**To: Durham Planning Board**

**Subject: Questions/Comments on landscape plan for Mill Plaza development**

From: John Parry, 5 Denbow Rd., Durham, NH

**SECTION 1 PROTECTION FOR EXISTING TREES**  
Scale: Not To Scale

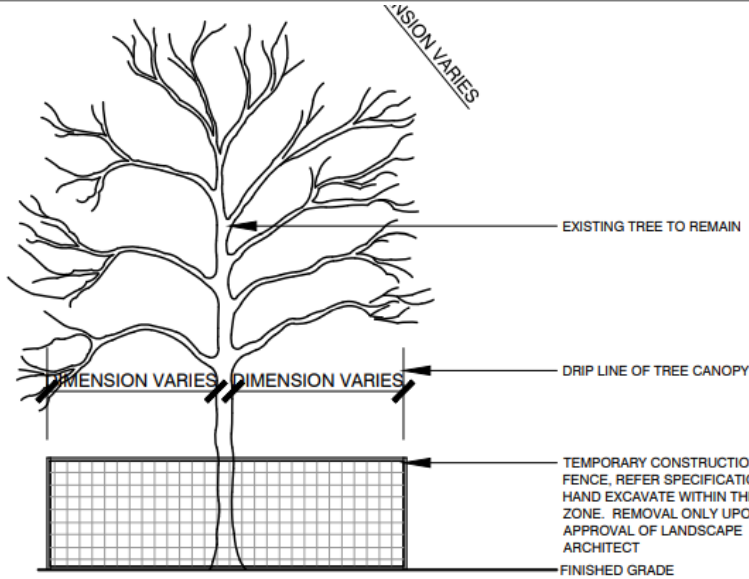
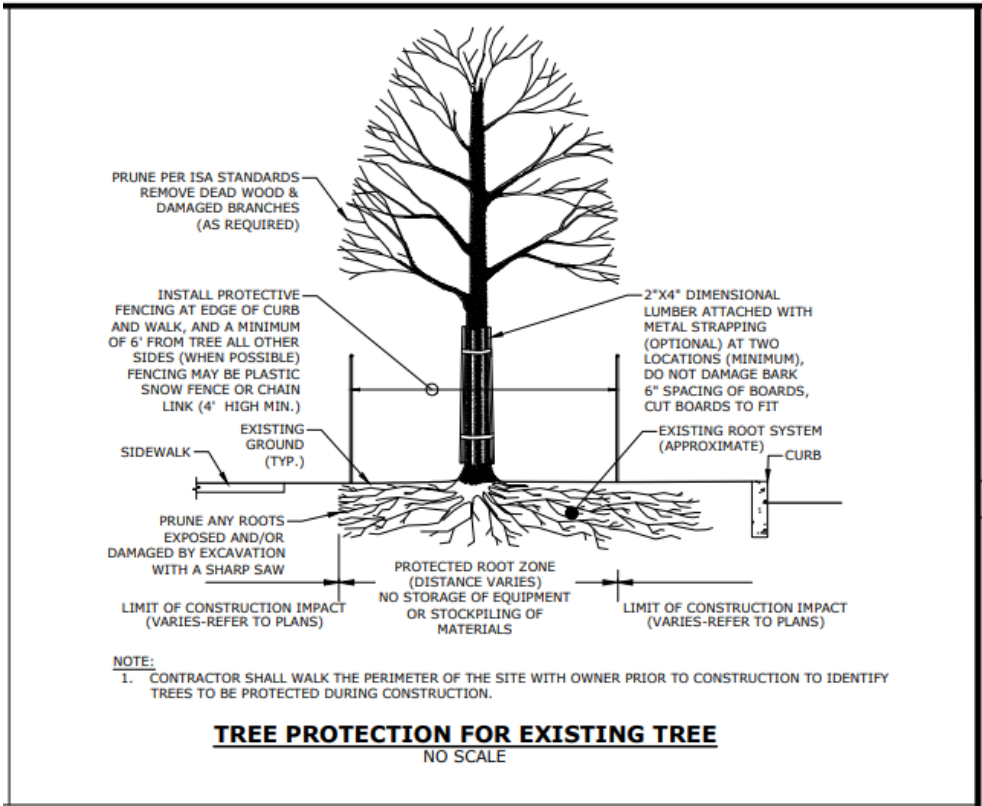
- Landscape Note 17. on the plan states; *EXISTING TREES AND SHRUBS SHOWN ON THE PLAN ARE TO REMAIN UNDISTURBED. ALL **EXISTING TREES AND SHRUBS SHOWN TO REMAIN** ARE TO BE PROTECTED WITH A 4-FOOT SNOW FENCE PLACED AT THE DRIP LINE OF THE BRANCHES OR AT 8 FEET MINIMUM FROM THE TREE TRUNK. ANY EXISTING TREE OR SHRUB SHOWN TO REMAIN, WHICH IS REMOVED DURING CONSTRUCTION, SHALL BE REPLACED BY A TREE OF COMPARABLE SIZE AND SPECIES.*

It is difficult to see on the plan **which trees are identified for protection?** I believe some are along Mill Rd. There could also be some in the College Brook area and along the northeast boundary of the property. Ideally the **Town Tree Warden and LA should identify and flag trees to protect prior to any construction activity. ID on the plan which trees will be protected and how.**

- Protecting rooting zone around the tree is very important. Fencing at the drip line is an accepted industry standard\* (There are also other accepted methods for determining the rooting area to protect). The plan wording in note 17. above “or at an **8 foot minimum**” is **contradictory and not adequate** for larger trees over 8” in diameter.
- There are **two different diagrams in the plans** showing different levels of tree protection (see below). The first figure below (from Sheet C508) shows fencing at 6 feet.
- The **protection standards for existing trees are confusing and need to be clarified.**

Photo Caption: Parking lot at Greenland Target store with 10 foot islands.

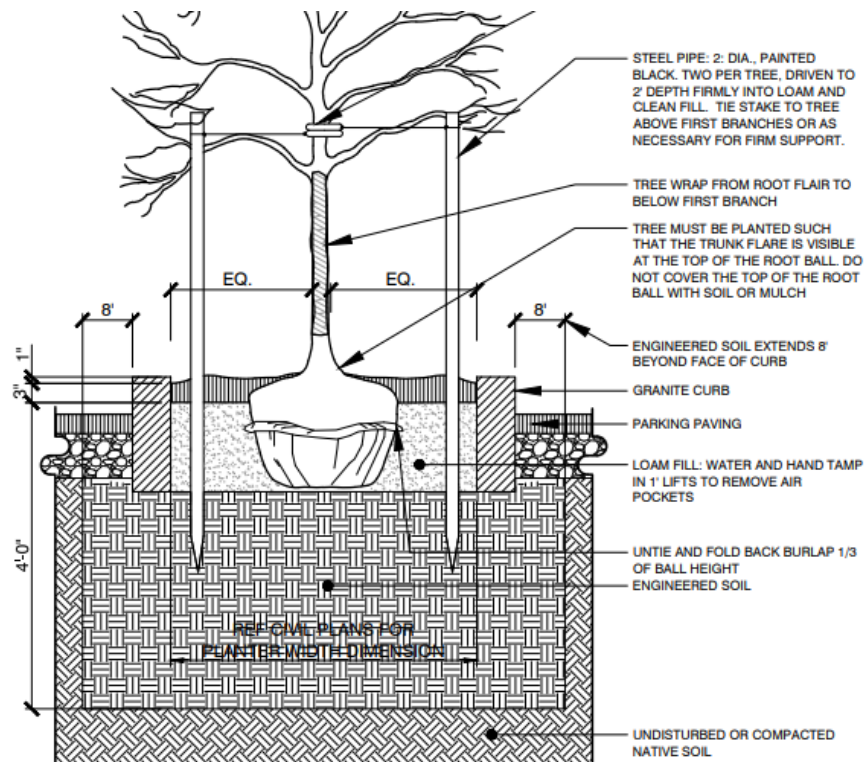
- The islands are 6 feet wide. My understanding is that measurement is to the outside of the curb, so the curbs will take up about 12+ inches of the island space. That **leaves just 5 feet or less of soil width for tree rooting** within the islands. Most tree roots naturally grow horizontally from the root ball. The species selected can grow to a larger size at maturity if adequate rooting space is available. Trees in the existing lot, and on main street are examples of what happens long term without adequate rooting space – they grow slowly, stay small, have poor health, are short lived and must be replaced regularly. I am glad to see species were selected that will have a larger size at maturity, but I feel **the width of the Islands should have been increased (to 8 feet or more) to allow adequate rooting space.** As an example, the picture below shows a parking median at Targets in Greenfield, with a 10 foot width and healthy trees growing at a good rate. Wider islands might also allow planting one or two additional trees in each island.

**4 DECIDUOUS TREE PLANTING: CENTER PARKING ISLAND**  
Scale: Not To Scale

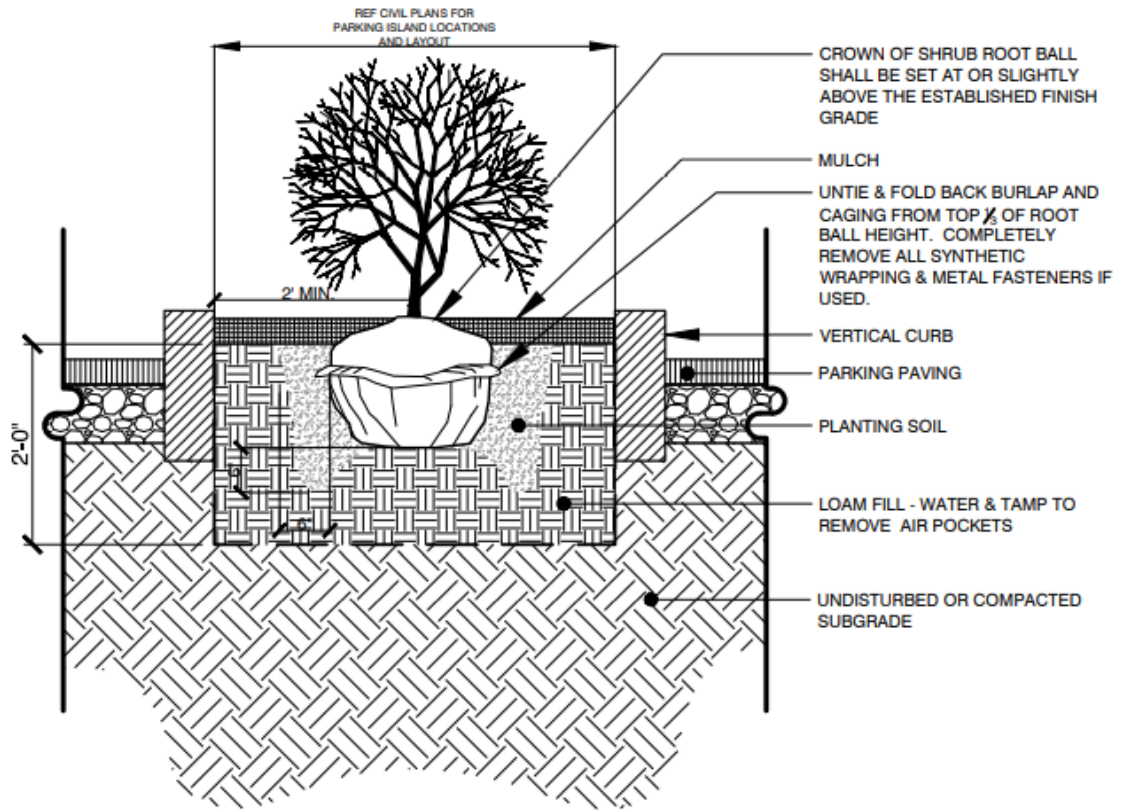
- The newest plans show that an “engineered” soil (ES) will be used and extends 8 feet beyond the curb, underneath the pavement. I assume this is similar to a structural soil which will allow tree root growth, and also support pavement or concrete above? **This ES should be defined or described in the plans.**
- Glad you are considering using ES, since this can help increase rooting space for trees when used correctly. It should be noted that because of the large volume of stone in **ES, it is less productive**

- The main benefit of using a structural soil or ES is that it supports concrete or pavement above, while also allowing root growth. The plan shows using ES directly under the trees (and 1' of loam) from a 1' depth down to 4'. **Since there is no pavement or concrete to support in the islands, just use a good soil** (at least 3 feet deep) in the islands instead. Tree growth will be much better. I spoke with one of the developers of structural soil at Cornell Uni. And she agreed with the above.

- There is **no engineered soil shown under the planned shrubs in the island, so that implies that the engineered soil does not run the full length of the island** and is only near the trees? **It would be useful to know how far the engineered soil extends in all directions.**

- The tree planting figure above shows the root ball planted high, about ¼ of the root ball is above the soil. **I feel this is inappropriate. Trees should be planted so that the root flare is established at or near ground level.** If soil settling is a concern, trees can be planted slightly high (no more than 1 – 2 inches high). The **ANSI standard for tree planting** (ISA Tree Planting BMPs – Companion Publication to ANSI A 300 Part 6) states that “B&B root balls should have the trunk flare correctly located at the surface – the planting hole can be 1 -2 inches shallower than the root ball depth in anticipation of minor settling and flattening of the root ball”\*.
